**TOWN OF PORTOLA VALLEY  
ARCHITECTURAL AND SITE CONTROL COMMISSION (ASCC)  
Monday, December 9, 2013  
Special Field Meetings (time and place as listed herein)  
7:30 PM – Regular ASCC Meeting  
Historic Schoolhouse  
765 Portola Road, Portola Valley, CA 94028**

# MEMORANDUM

**TO:** ASCC  
**FROM:** Tom Vlastic, Town Planner  
**DATE:** December 5, 2013  
**RE:** Agenda for December 9, 2013 ASCC Meeting

**4a. BUILDING PERMIT REVIEW OF "MONOPINE" COLLOCATION ANTENNA PLANS FOR CONFORMITY WITH CONDITIONS OF CUP X7D-132 (VERIZON WIRELESS) AND CUP X7D-138 (AT&T MOBILITY), THE PRIORY SCHOOL, 302 PORTOLA ROAD**

PROJECT NO. 123584-01  
 SHEET NO. A-1

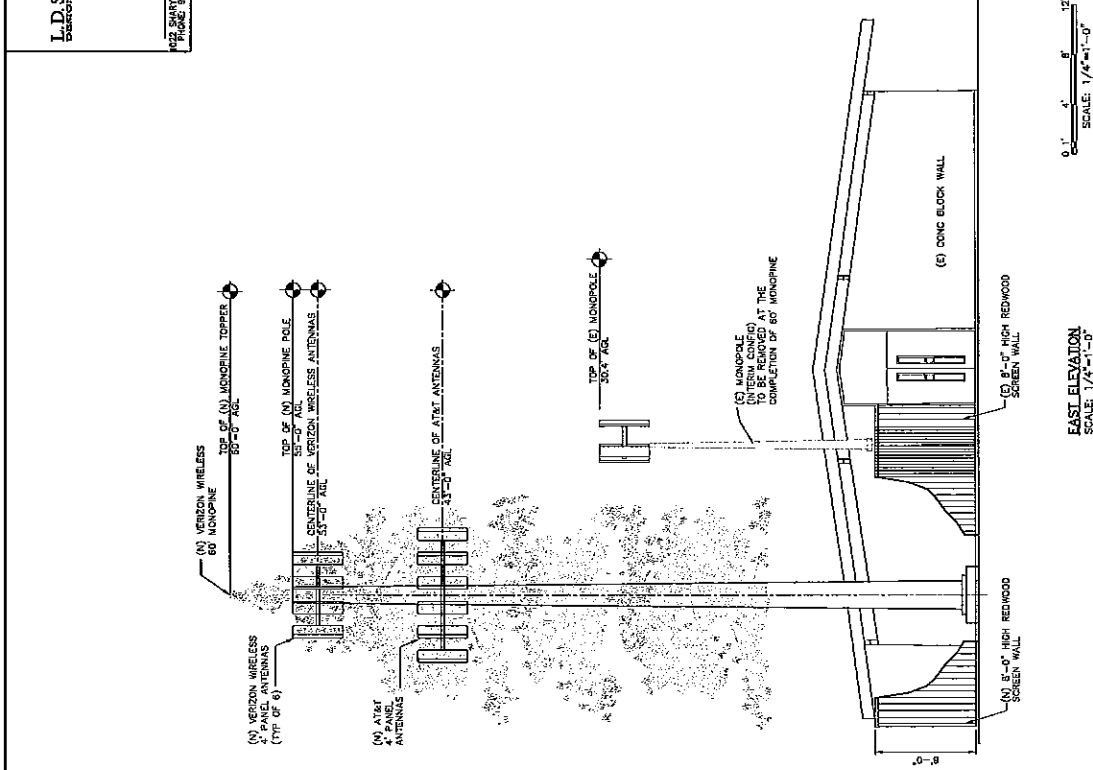
**Condition 4.** Screen landscaping as called for in this condition as clarified at the evening ASCC meeting is shown in the Partial Site Plan box on plan Sheet A-1. As noted in the ASCC 7/23 meeting minutes, the placement of the three, 24-inch box multi-stem live oaks will be field set, and agreement for their maintenance will be needed to the satisfaction of staff prior to actual release of the building permits.

DRAWING: MIB | DATE: 11/14/12  
 FILE: 4372-42  
 SHEET NO. **A-2**

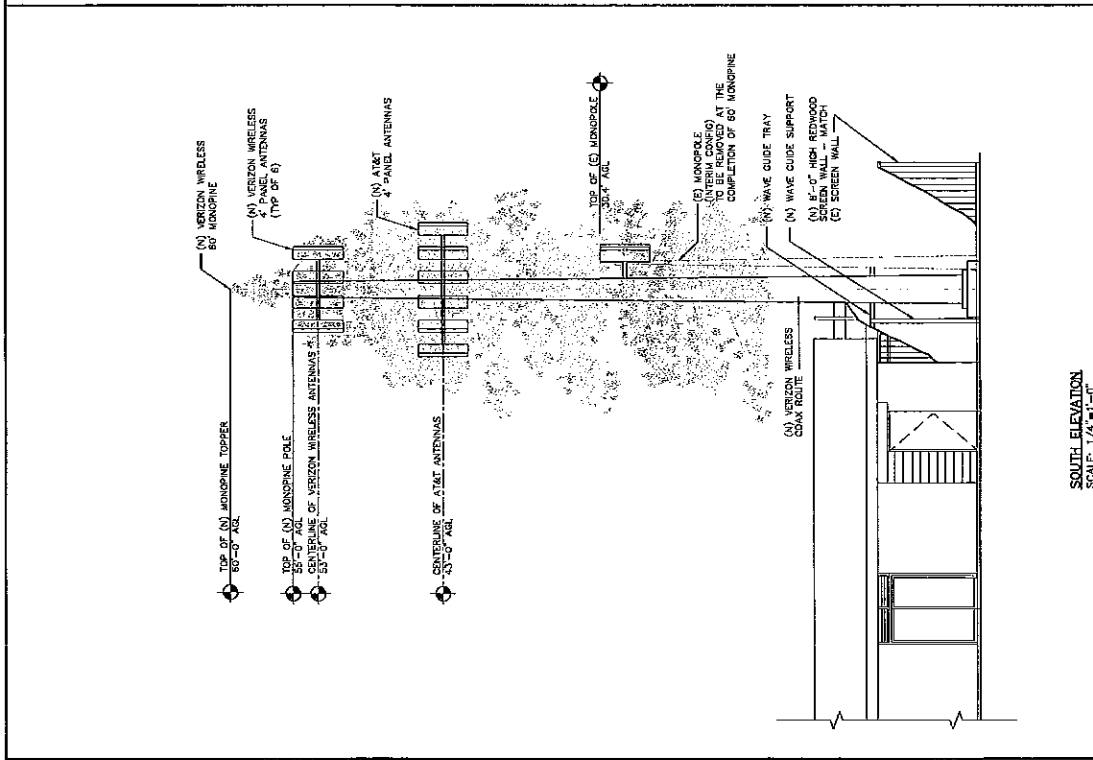
**Condition 3.** The tree height is 60feet, consistent with the condition, and the branches now are to start very close to the top of the Monastery building (refer to Sheet A-2).

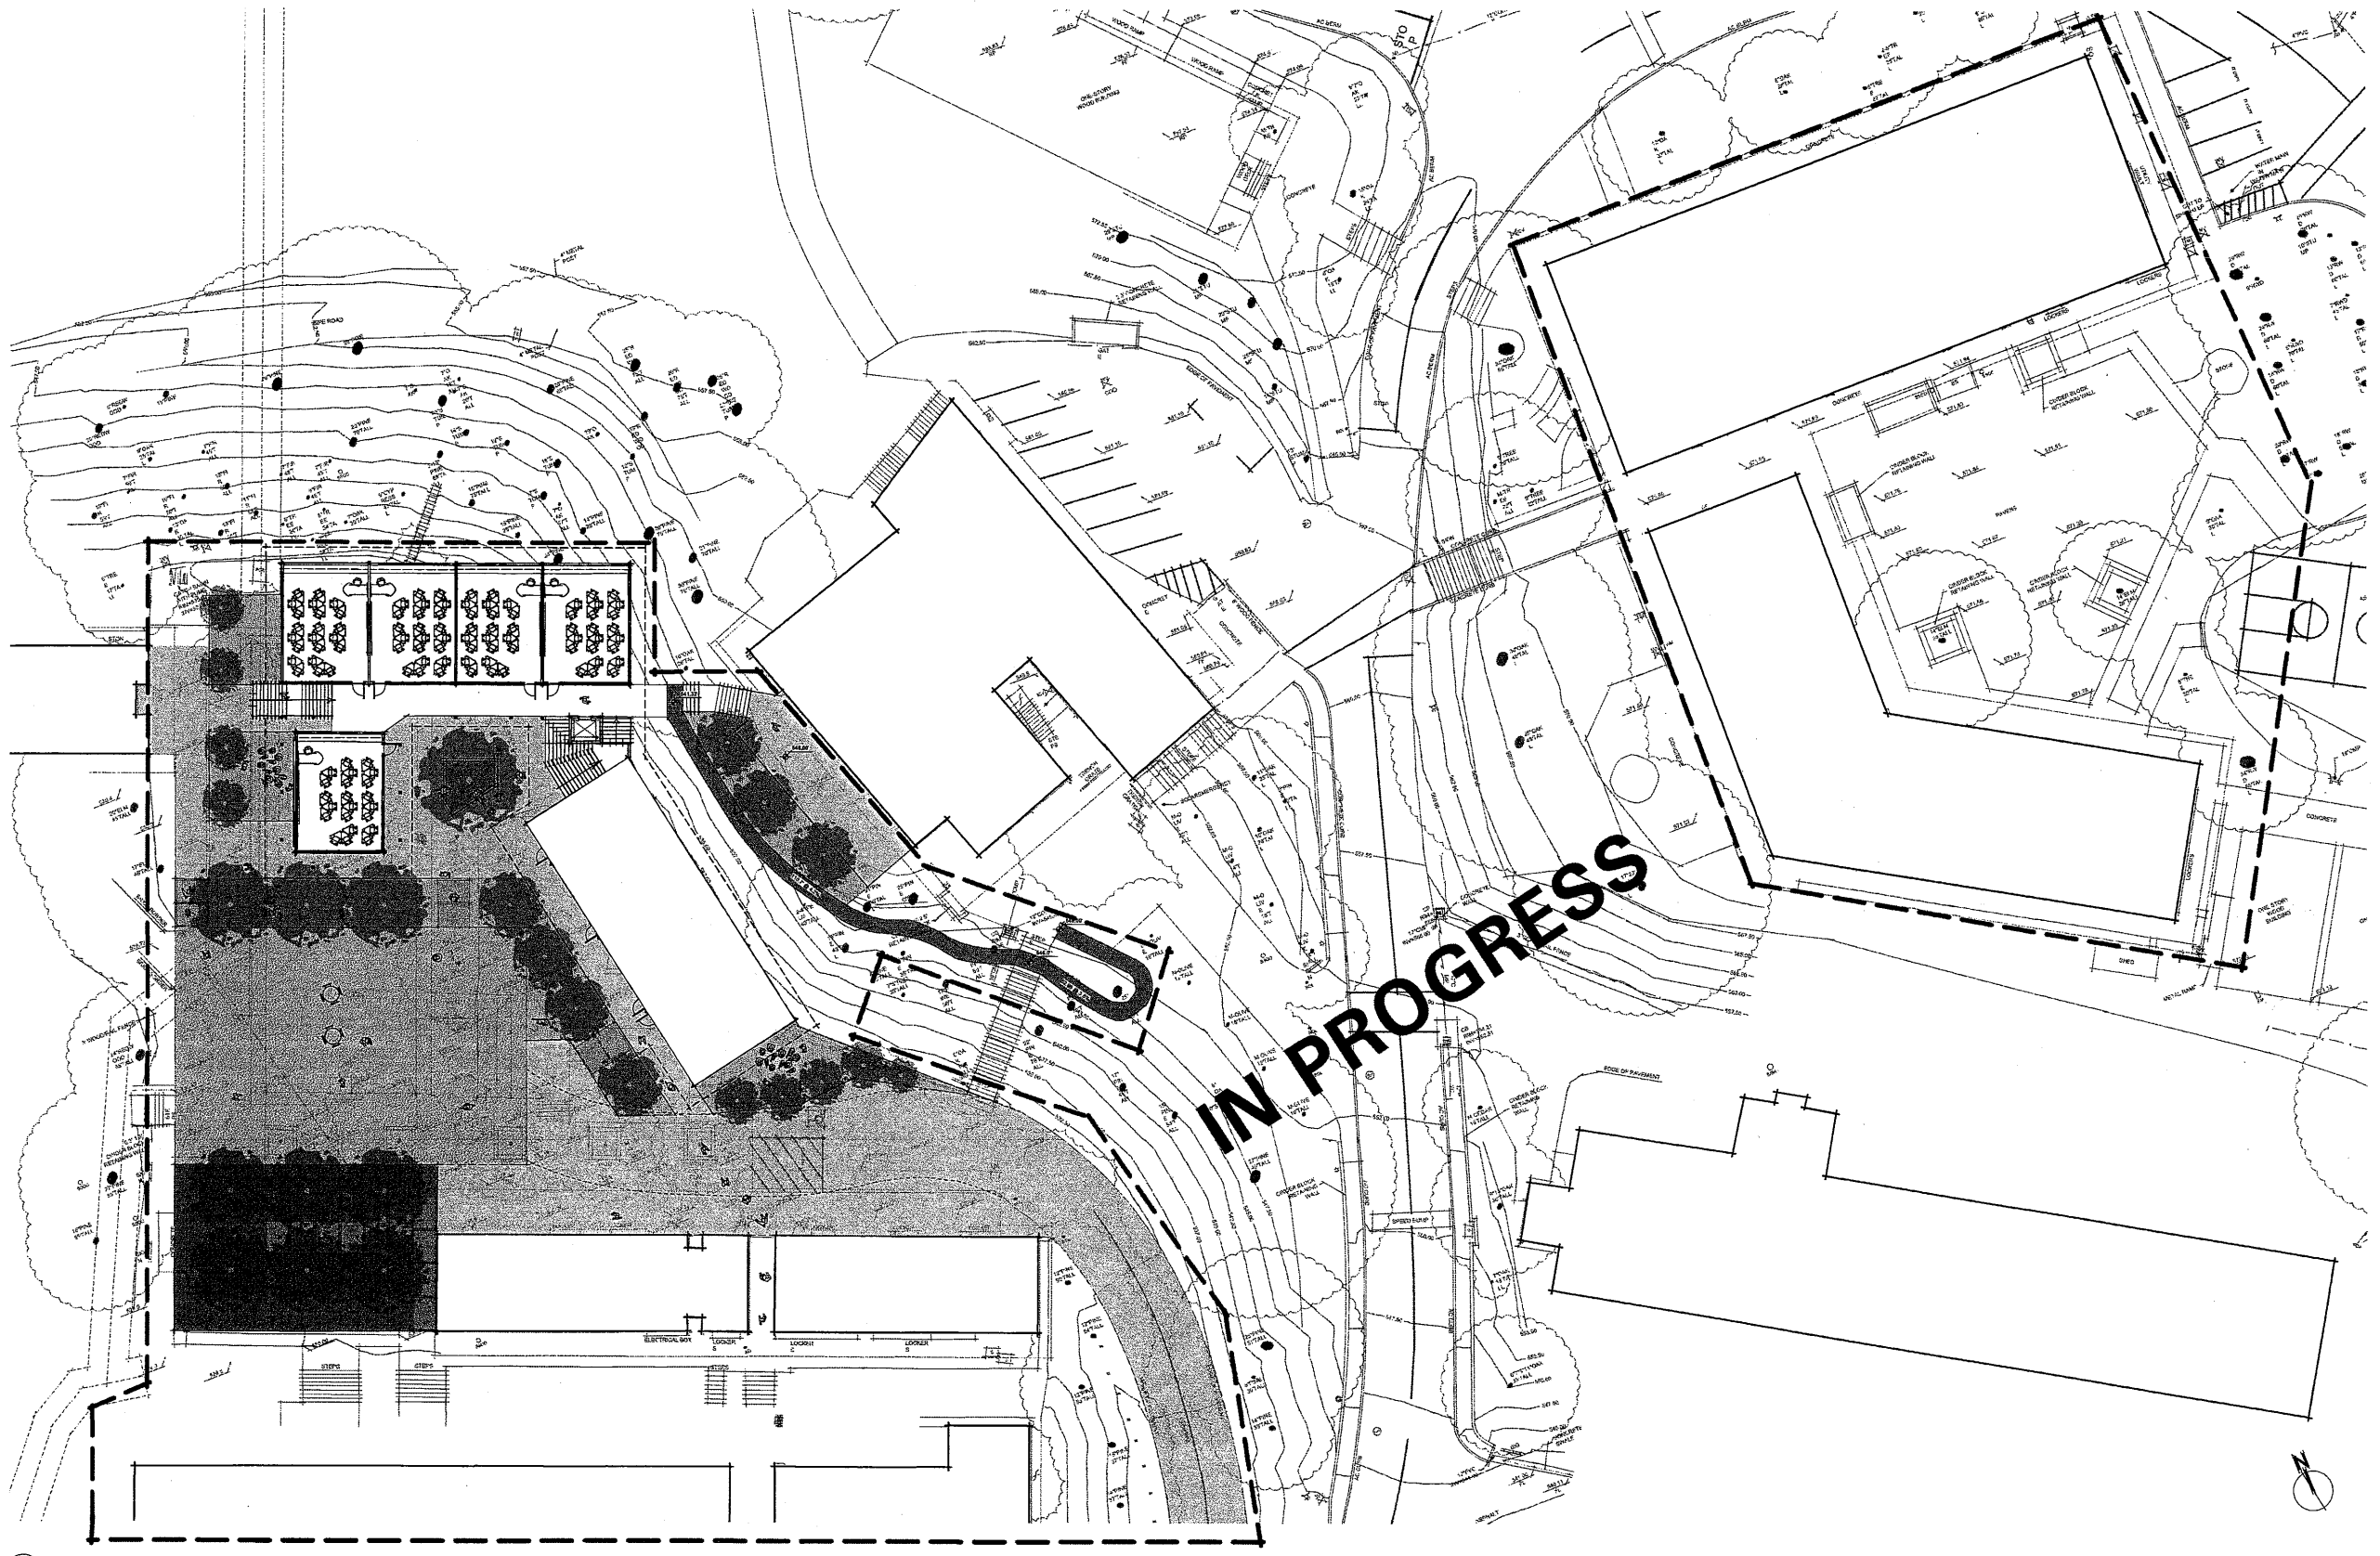
1. **Considerations regarding Zoning Ordinance Regulations and the Design Guidelines.** More detailed plans and information, including elevations and landscaping plans, will be needed to assess full conformity with the Town's zoning regulations and design guidelines. However, based on discussions with Priory representatives to date, we do not anticipate any significant issues. One key consideration will be whether the proposed building design includes any features that could create glare, lighting or other visual impacts on nearby properties, including those across Portola Road. This can be considered once building elevations are available. Hopefully, the architectural team will present at least rough elevation concepts for discussion at Monday's meeting.

2. **Consistency with the Conditional Use Permit and the Priory Master Plan.** The approved master plan shows demolition of the three buildings in Benedictine Square and construction of a new building with offices and classrooms located around the existing Student Center. An enlargement of the approved master plan diagram showing both Benedictine Square (located near letter E and labelled as "Benedictine Square") and Church Square (located at letter G) is attached. The proposed new classroom buildings are located very close to where they are shown on the master plan, although pulled a little further out from the hill and the Student Center. In addition, one wing has been moved west so that it is located along the north side of Benedictine Square instead of wrapping around the Student Center. Overall, the location for the buildings appears to be generally consistent with what is shown on the master plan.
